3.6 Individual Comments and Responses

**2012 Central Valley Flood Protection Plan
Final Program Environmental Impact Report**

Figure D-20. Grimes Levee Approach

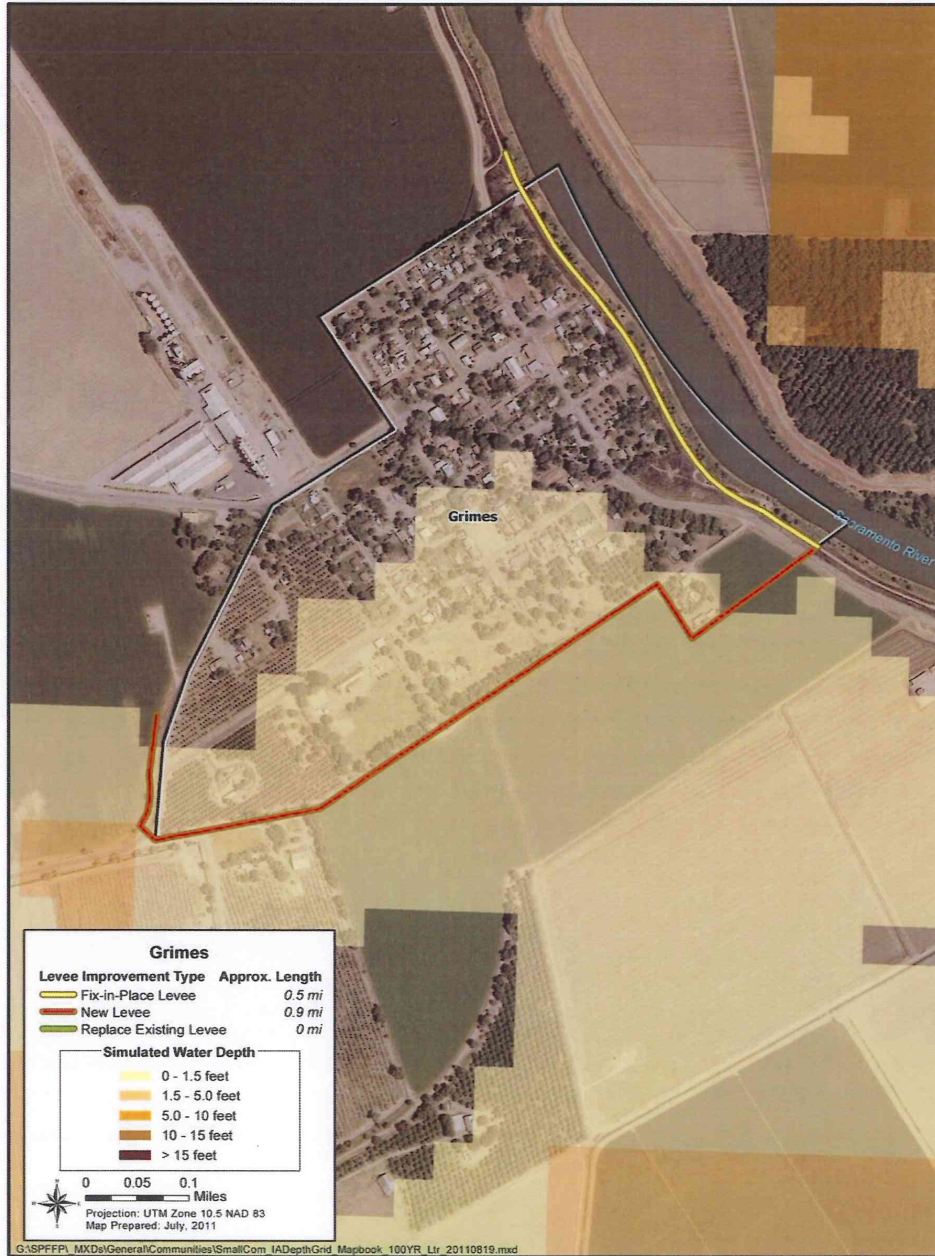
Currently, the plan proposed to reinforce the levee adjacent to the community of Grimes but then recommends building a setback levee beginning on the southside of town and removing the existing levee (see attached Figure E-14 and related discussion). This will result in the loss of several acres of farm land as well as the historically significant home and the Moore brothers' marina. Rather than produce income for our family, feed people around the world, and provide access to the River for local residents, these lands will revert to riparian habitat. This will be a large loss to the town of Grimes and a devastating loss to the Moore family.

Figure E-7. MSAC3 Conceptual Setback Area, Sacramento River

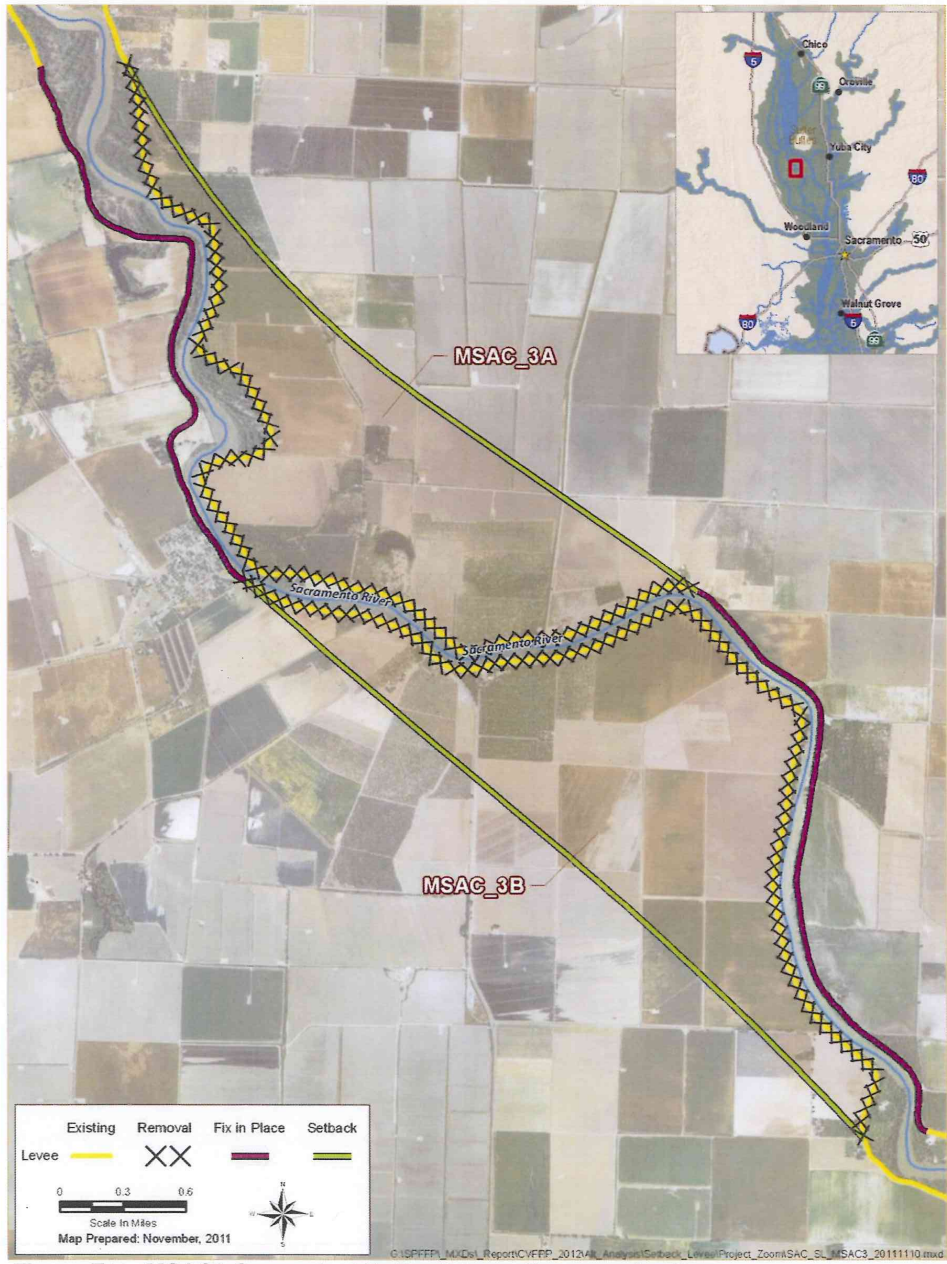
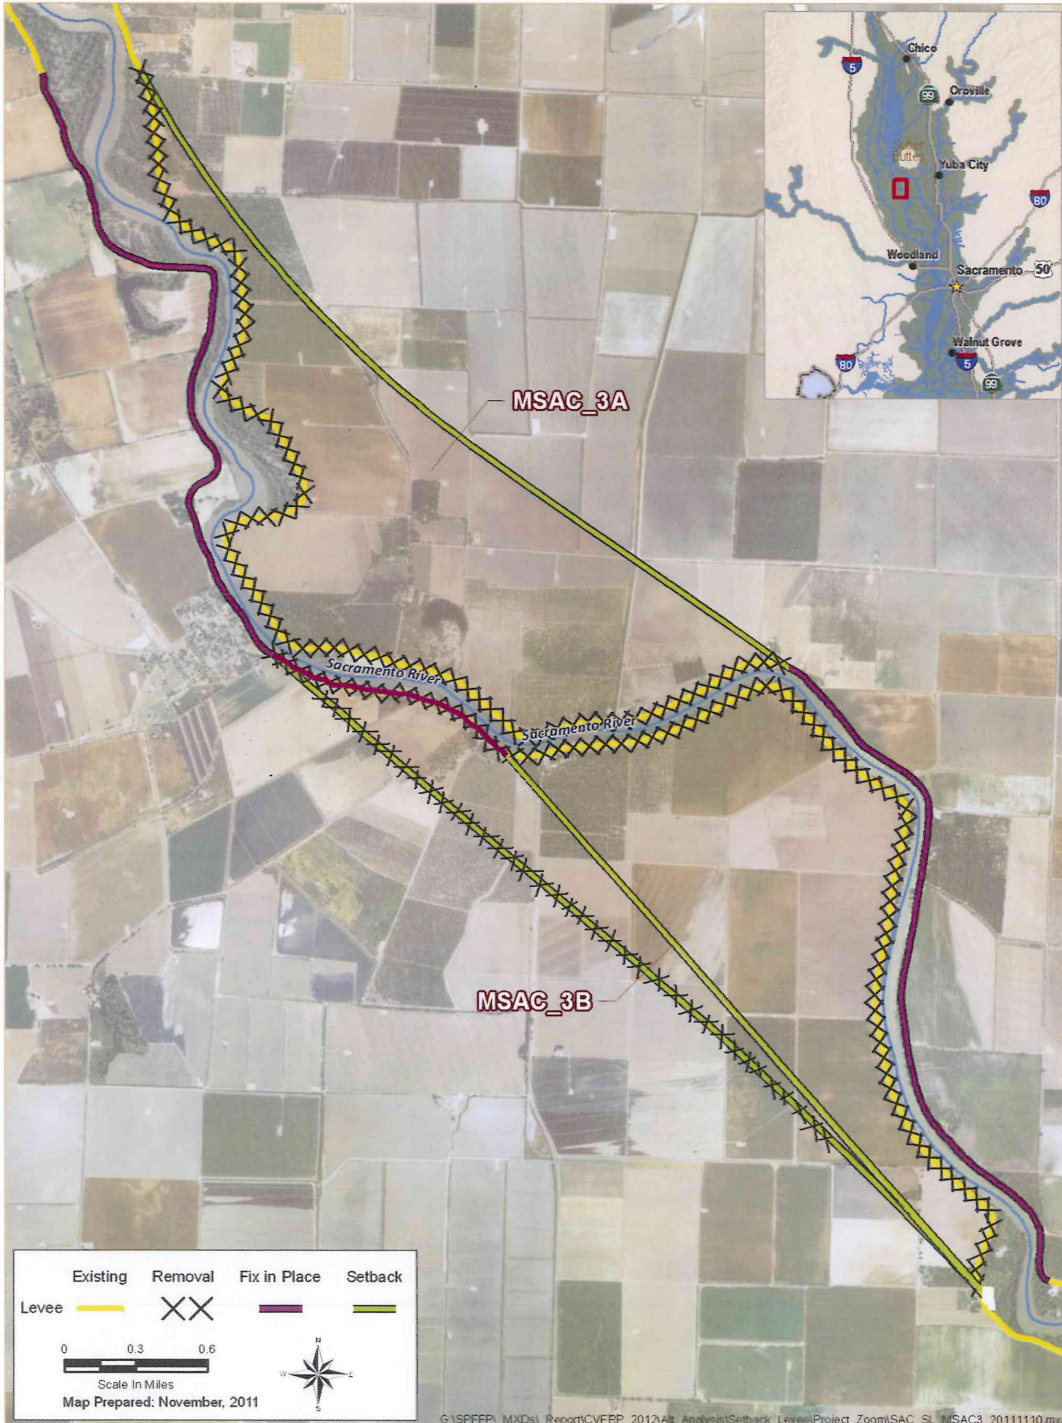
As such, we humbly request that the Board modify the draft plan with respect to a setback levee south of Grimes (including but not limited to Figure E-7, attached, and the discussion on page D-50) to remove the proposed setback levee on the west side of the River and instead "fix in place" the existing levee south of Grimes. This alternative will provide protection from a one percent AEP flood for the broad community of Grimes, including its industry, historic places, and amenities. In the alternative, if a setback levee is necessary to meet the goals of the CVFPP, we request that its alignment be modified as shown on Exhibit A (attached). This alternative alignment will reduce impacts to agriculture while avoiding the historic Moore Family home and the only marina.

The comment references the conceptual levee setback element depicted on a map shown as Figure E-7, page E-14 map in DPEIR Appendix A, “Central Valley Flood Protection Plan,” Attachment 8J. As stated in Master Response 20, this particular conceptual setback was developed primarily for cost evaluation and comparison purposes. Specifically, Tables 6-11 and 6-15 in Attachment 8J, “Cost Estimates,” found in Volume IV of DPEIR Appendix A, “Central Valley Flood Protection Plan,” summarize the cost items assumed for the Enhance Flood System Capacity approach and for the SSIA, respectively. The cost of any rural setback levees (including the conceptual setback of concern to the commenters) is reflected in Column 15, “Rural Setback Levees,” of each table. When comparing these two tables (regarding the SSIA and Enhance Flood System Capacity approach, respectively), the costs of conceptual rural setback levees were included in the Enhance Flood System Capacity approach (Table 6-11), but the corresponding value in Table 6-15 is zero, further confirming that the conceptual levee of concern to the commenters is not included in the recommended SSIA.

Other documents support the conclusion that the levee setback element of concern to the commenters was not included in the recommended SSIA. For example, Figure 7-25 in Attachment 7, “Plan Formulation Report,” found in Volume II of DPEIR Appendix A, “Central Valley Flood Protection Plan,” illustrates all the elements included in the Enhance Flood System Capacity approach. It shows a setback levee area in the lower Feather River under this approach. However, this setback element is not carried forward in the SSIA, as depicted in Figure 8-1 in Attachment 7 and in Figure 3-1 of the Public Draft CVFPP (these are the same figure).

Excerpt from Central Valley Flood Protection Plan, page 3-14, 3-15:

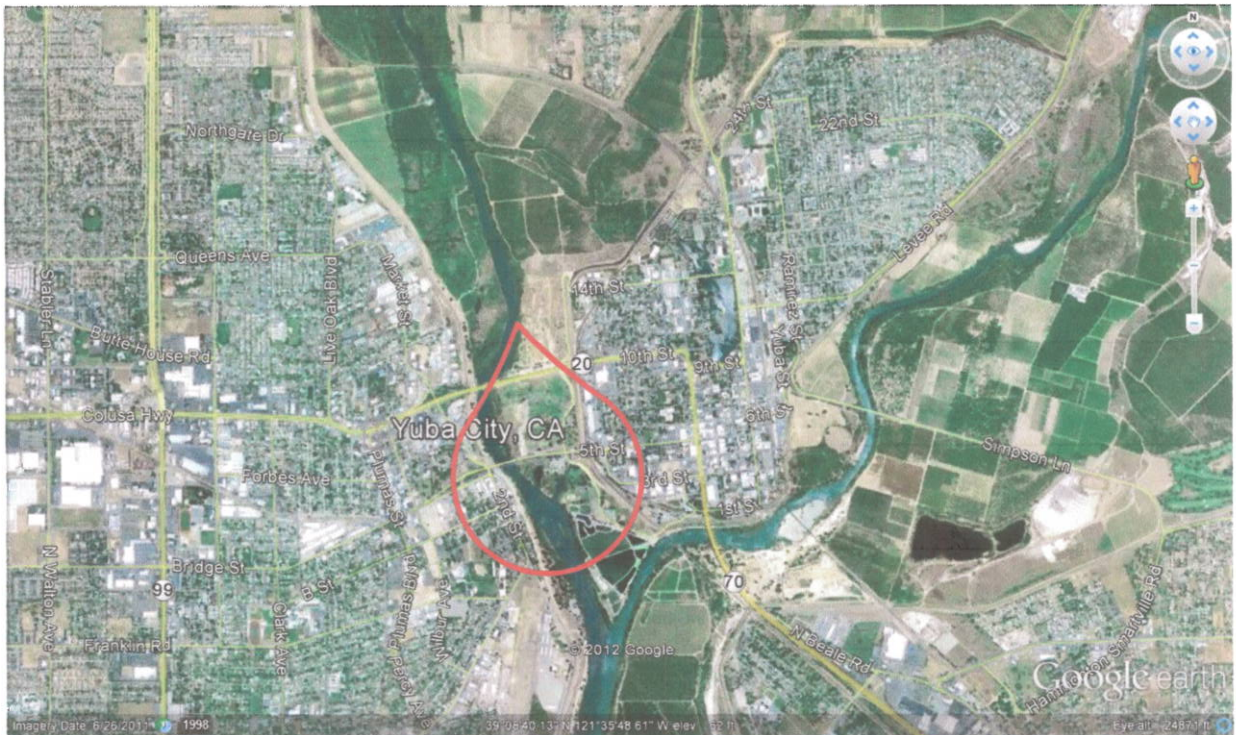
“• This approach also includes a potential new bypass to divert flows from the Feather River downstream from Oroville Dam along the alignment of Cherokee Canal into Butte Basin. Initial analyses indicate that a bypass with a capacity of 32,000 cubic feet per second could reduce peak flood elevations along the Feather River and help convey flood flows into the existing bypass system.”

Evaluate the feasibility of constructing a new bypass from the Feather River to the Butte Basin to further contribute to improving overall urban, small community, and rural-agricultural flood protection in the planning area. The new bypass would require construction of about 16 miles of new levee on one side of the Cherokee Canal.

Figure D-20. Grimes Levee Approach

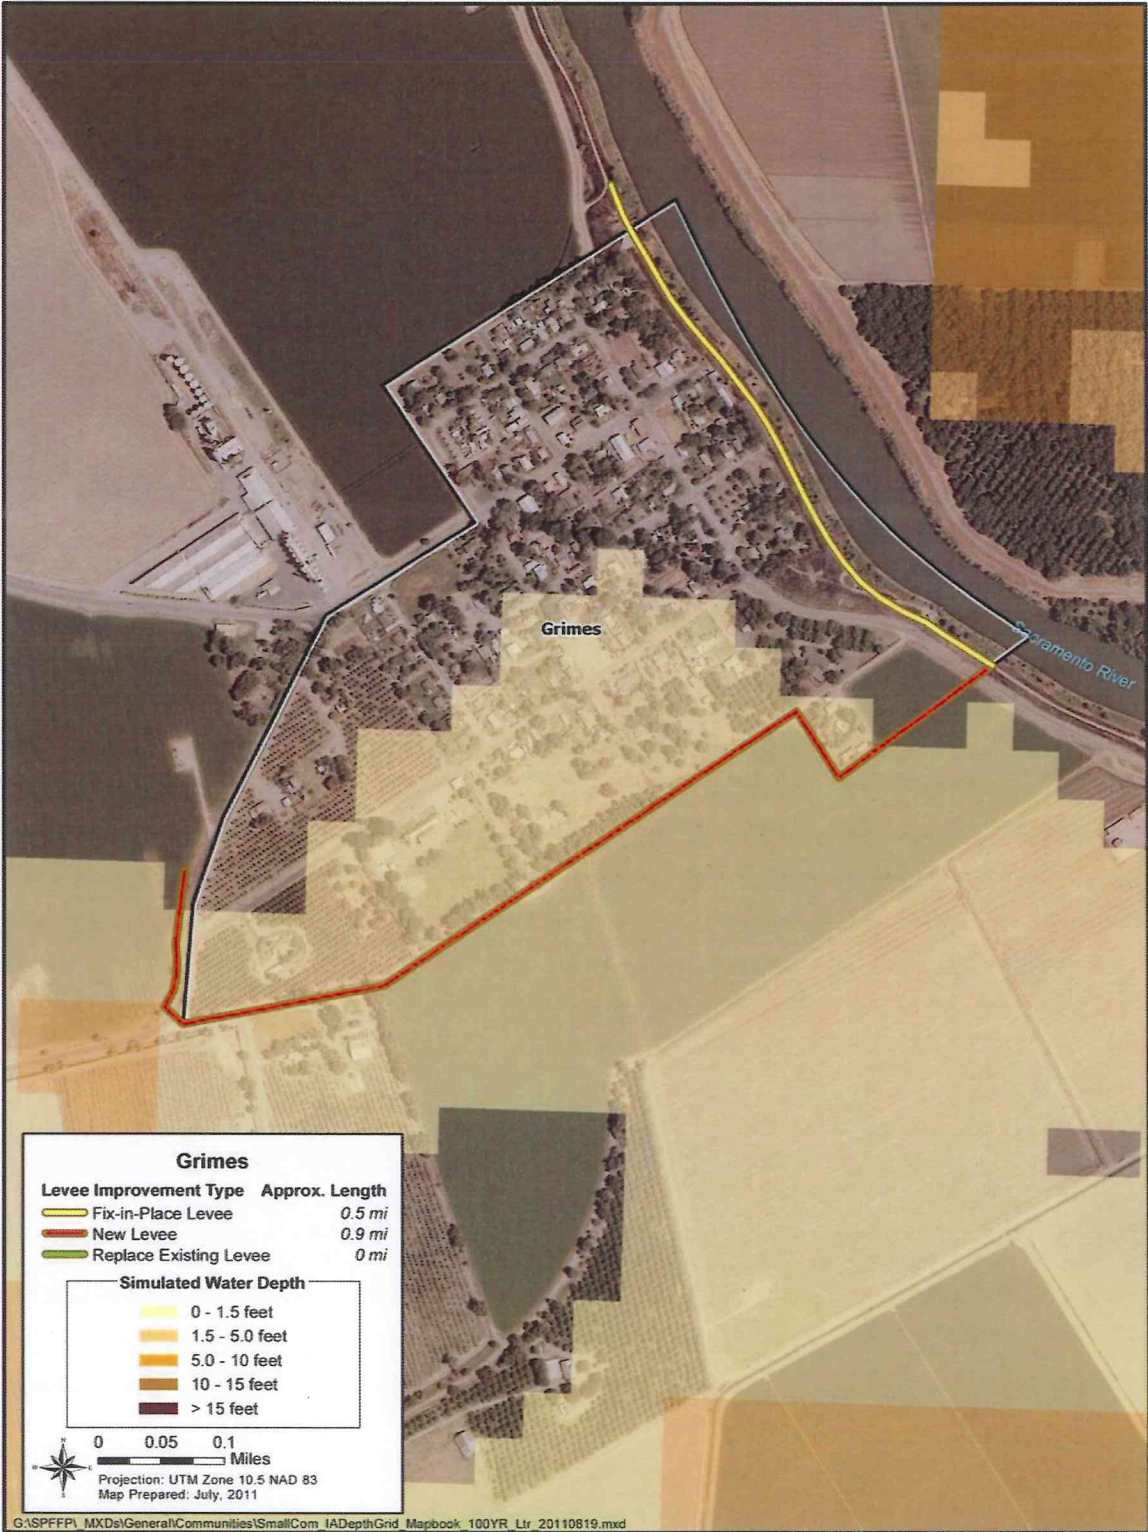
Currently, the plan proposed to reinforce the levee adjacent to the community of Grimes but then recommends building a setback levee beginning on the southside of town and removing the existing levee (see attached Figure E-14 and related discussion). This will result in the loss of several acres of farm land as well as the historically significant home and the Moore brothers' marina. Rather than produce income for our family, feed people around the world, and provide access to the River for local residents, these lands will revert to riparian habitat. This will be a large loss to the town of Grimes and a devastating loss to the Moore family.
